## Reelmaster® 335-D

**Subject:** Performing repairs to Front Drive Axle and Bearing.

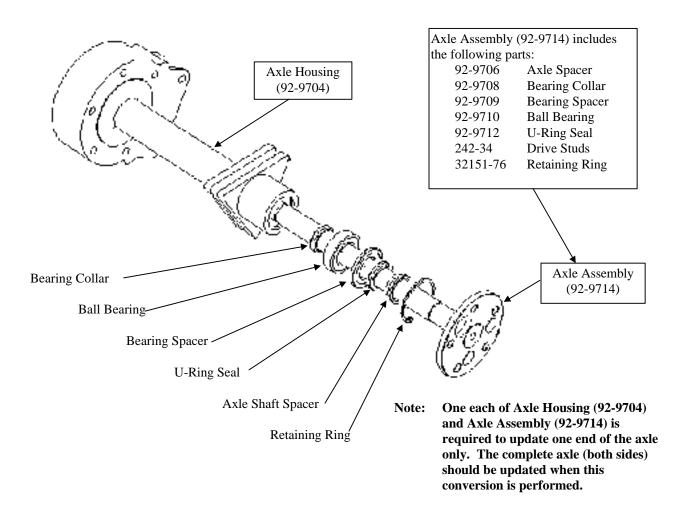
Axle parts used in later machines will retrofit to the units in the serial range listed above. These parts enhance the durability and increase the capacity of the axle to withstand higher load conditions. If you experience a failure in the front axle, you should consider updating to the latest design. The Axle Assembly (92-9714) and Axle Housing (92-9704) required to complete this update are identified in the illustration below. We recommend that both sides be converted when performing this repair. Parts are available through your local Toro distributor.
